Project: Phase 7 Pile Remediation – Marine Construction Services

RE: Addendum #3

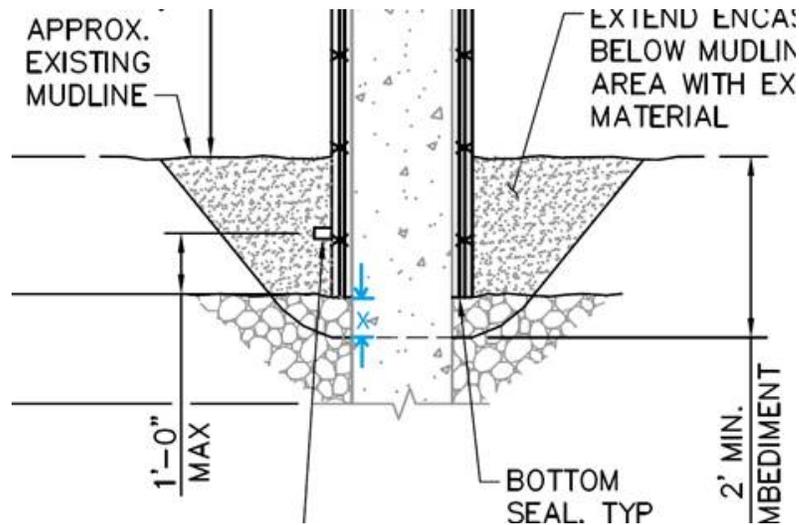
20. Detail B2 on S-501 shows a dimension leader longer than it shows the pile encasement. Should the area shown as “X” in the detail below be included in the repair? That’s to say, should the repair extend down into the area labeled “X”? Is it the design intent for the encasement to be embedded the full 2’?

Response: A minimum 2’ embedment needs to be achieved for soft bottom repairs. In the illustrative drawing above, which was modified by a prospective Proposer, Dimension X in the detail of the above drawing should be included in the repair.
